# QR18: PRODUCT CHANGE NOTICE

<b>Date of Notice:</b> (DD/MM/YYYY)	7 <sup>th</sup> May 2021	<b>Product Change Notice Number:</b>	USB4105 B PCN 20210607
--	--------------------------	--------------------------------------	------------------------

**Product Identifier:** USB4105-GF-A

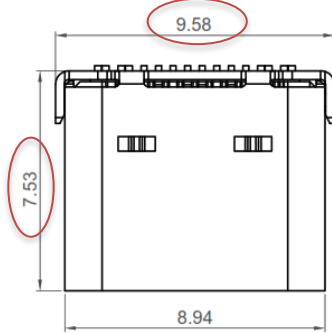
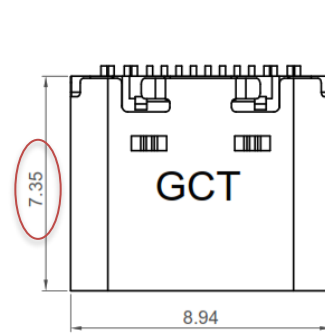
Add GCT logo to the shell.

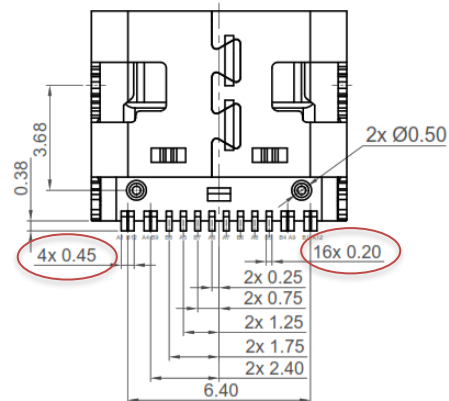
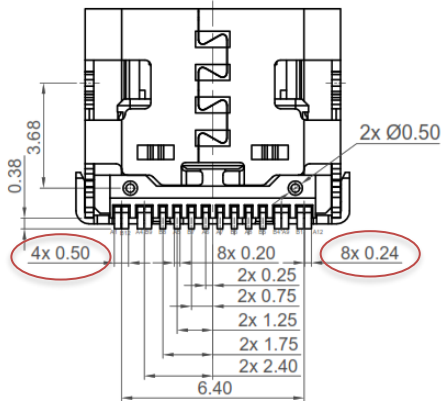
Rear flap replaced with tangs to retain the insulator, reducing the effective width from 9.58mm to 8.94mm & total length from 7.53mm to 7.35mm.

Contact widths changed from 0.24mm to 0.2mm & 0.5mm to 0.45mm.

Tolerances added to mating faces.

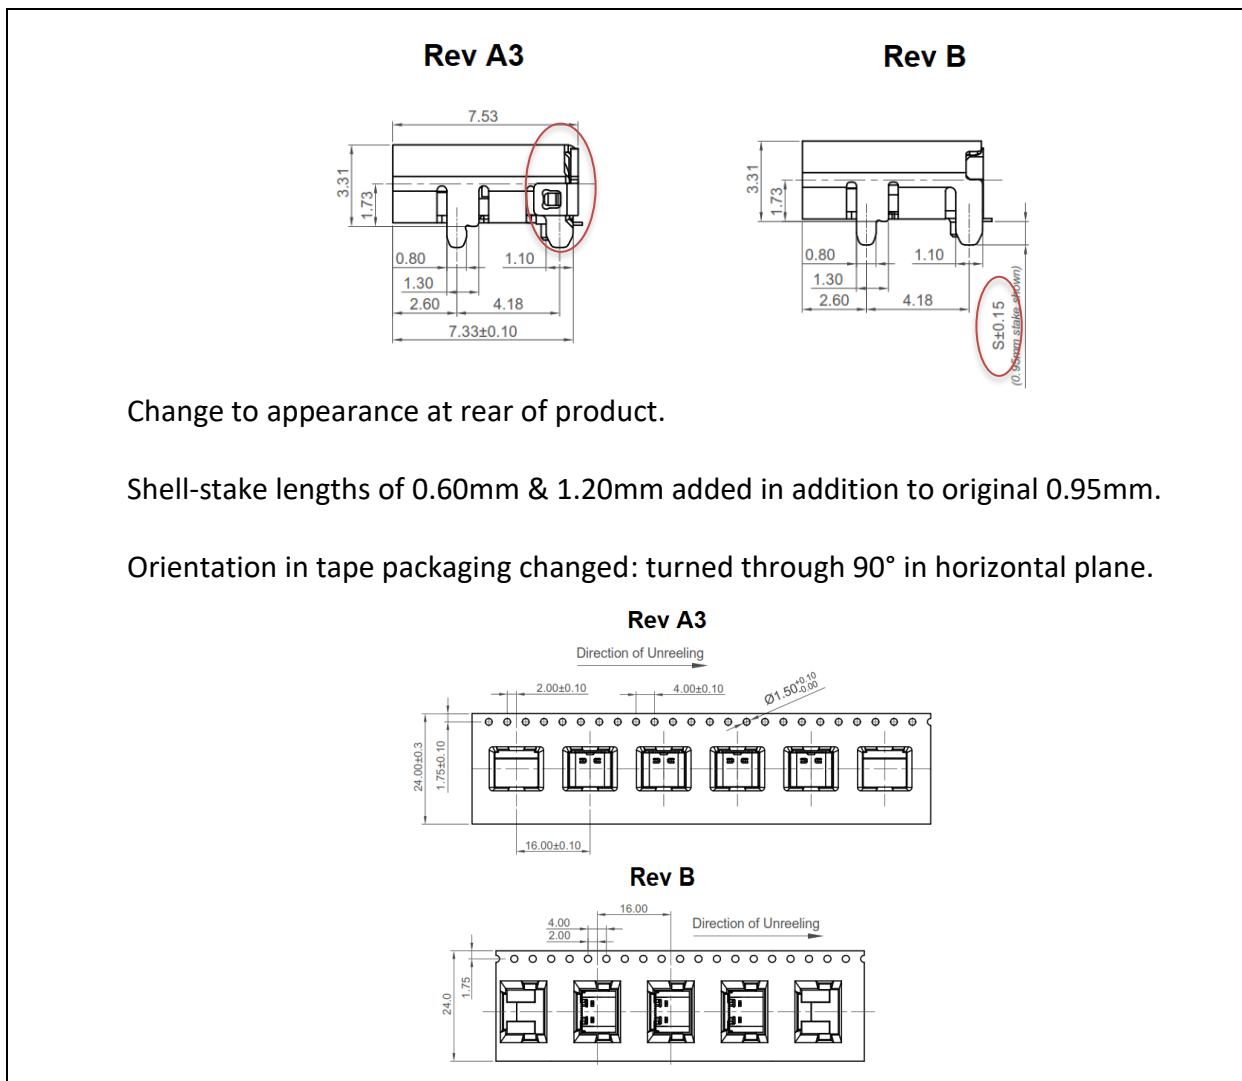
Location peg changed from 0.65mm to 0.6mm.

Change to appearance at rear of product.

Shell-stake lengths of 0.60mm & 1.20mm added in addition to original 0.95mm.

Orientation in tape packaging changed: turned through 90° in horizontal plane.
